European Network of Transmission System Operators for Electricity

NETWORK CODE ON "REQUIREMENTS FOR GENERATORS"

EVALUATION OF COMMENTS

26.06.2012

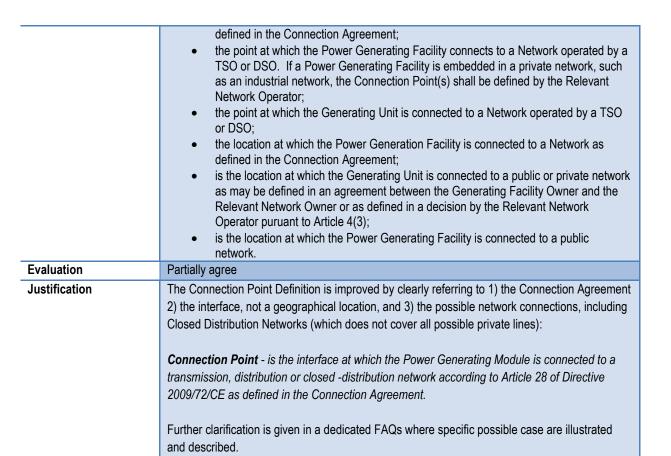
Issue	"Connection Point" Definition
Section	Article 2 – Definitions (Glossary)
Proposal	 The definition of Connection Point is an unclear definition, therefore a high risk of inadequate definitions for requirements to be proven at the Connection Point is possible (,legal gap'). Several proposals for Connection Point are provided: the point defined by the Relevant DSO or TSO at which the Power Generating Facility is connected to his Network; the location at which the Power Generation Facility is connected to a Network as

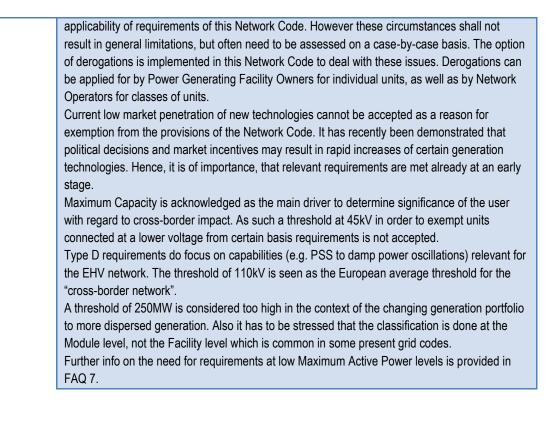
Issue	Change of the Table 1 Maximum Active Power and Voltage thresholds			
Section	Article 3(6)			
Proposal	From the perspective of manufacturers, the classification should be undertaken with no allocation to voltage levels. Besides, it is proposed to specify the range of each type giving no flexibility to the Member States for decision. E.g.: Type A: 3.68 kW – 1 MW; Type B: 1 MW – 50 MW; Type C: 50 – 75 MW; Type D: > 75 MW ; Other proposals included raising the voltage threshold of 110kV for type D to 170 kV. Some proposed to include a voltage threshold for type C requirements as well at 45kV. Some proposed to raise the Type D threshold to 250MW			
Evaluation	Disagree			
Justification	The significance test of users has to include voltage as prescribed by the FWGL. In addition a final decision on significance is to be taken at national level. The categorisation of Generating Units is based on assumptions of the future developments of the generation portfolio and the needs for secure system operation. A graded approach on significance by introducing different categories reflects the different levels of impact of generation units on cross-border network issues and shall be considered as significance criteria. It is accepted that various, possibly technology-specific, circumstances may limit the

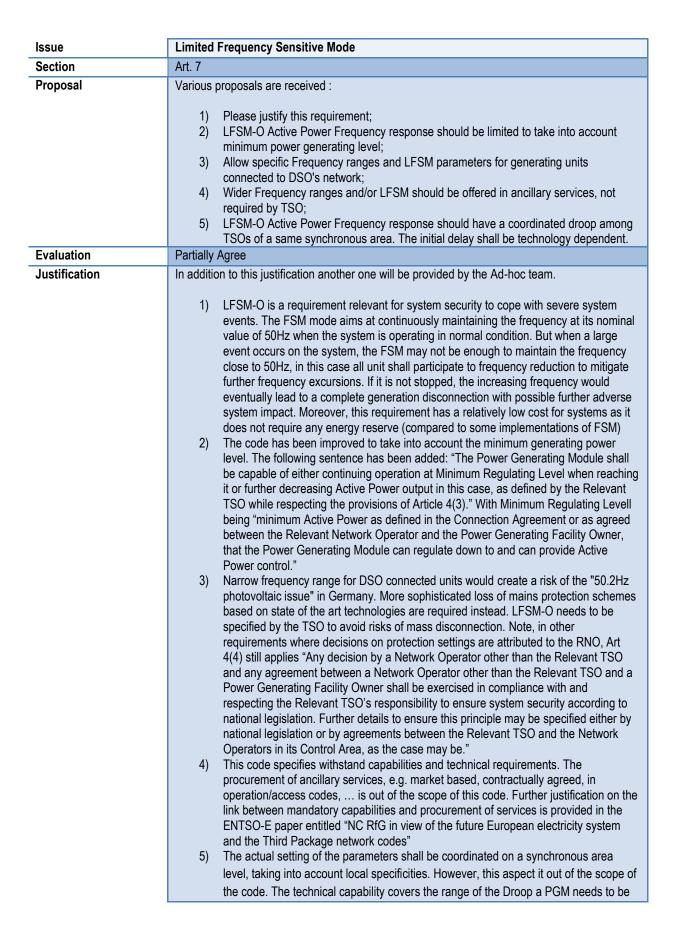
Issue	Combined requirement for voltage and frequency ranges		
Section	Art. 7		
Proposal	Add a table for combined requirements for voltage and frequency ranges in one diagram.		
Evaluation	Partially agree		
Justification	Combined interpretation of frequency and voltage ranges is elaborated in FAQ 20. As soon as one value of either voltage or frequency exceeds one of the criteria defined in this code (in magnitude of deviation and time period), units are not required to be capable to remain connected.

able to provide, the actual setting will be made by the Relevant TSO. Technology dependent initial delay of frequency response is already covered by the term "... as fast as technically feasible ...". Concerning settings of LFSM parameters, this document only describes requirement for connection, in actual operation of a network, the need is the global response.

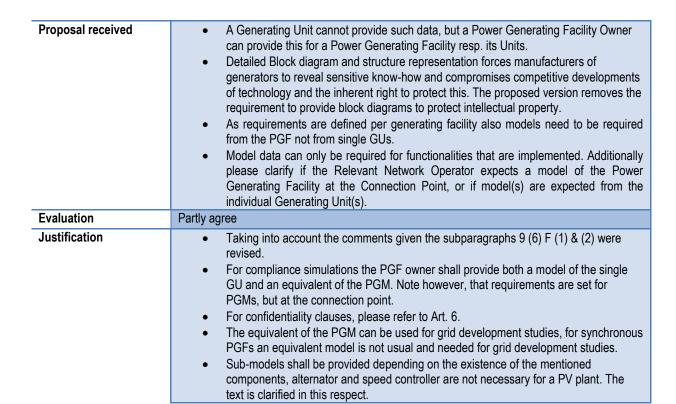
Issue	Simulation Models / general comments
Section	Article 9(6)f

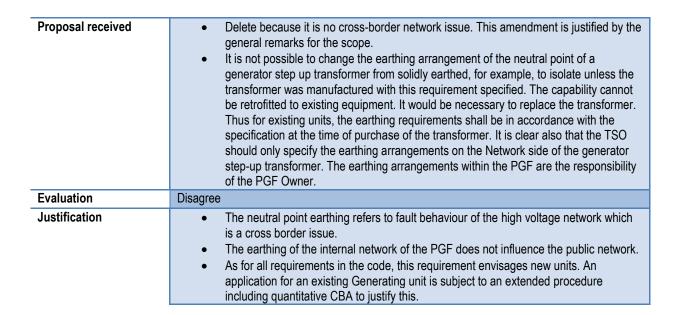
I	lssue	Earthing of Step-Up-Transformer
;	Section	Article 9 (6) i

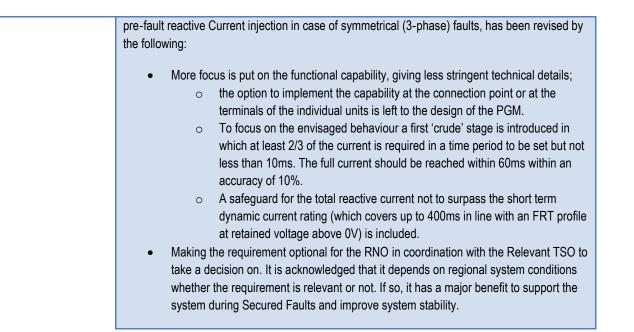
There is no coherence in the specification with respect to what is required at the Connection Point and what is required at the terminals of the Units. The FRT profiles are prone to wrong interpretation specification lacks clarity in several places, in some places not corresponding to state-of-the art in other places is in some respect much more demanding than present codes, without proper justification for fast current injection it specifies implementation methods rather than required behavior. In this way the required implementation lies close to many existing patents and prevents free trade in Europe. The changes required are so fundamental that they cannot be achieved by some editing in the
	text here and there.
Evaluation	Partly agreed
Justification	Article 15(2) on fast acting additional reactive Current injection at the Connection Point to the
